Access Compliance Report

Public Rights-of-Way

(Curb Ramps)

Intersection ID: N/A	Main Street: BARRINGER_DR	Cross Street: MAYFLOWER_RD	Location: SW
ADA ID: AF33CD700593	Ramp Type: Directional1	Initial Pass/Fail: Pass	Overall Compliance: No
Codes/Mitigation Info/Possible Solution		Field Measurements/Component Compliance	
Severity Score: 17.75

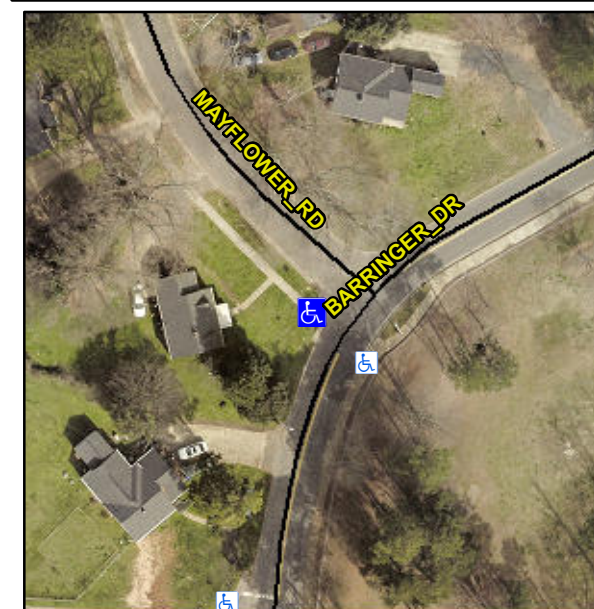
**Remove & Replace Entire Ramp.
Grind Gutter Lip.**

**R304.5.3, R304.2.2-Perp, R304.3.2-
Para, R305.1.4, R302.7.2**
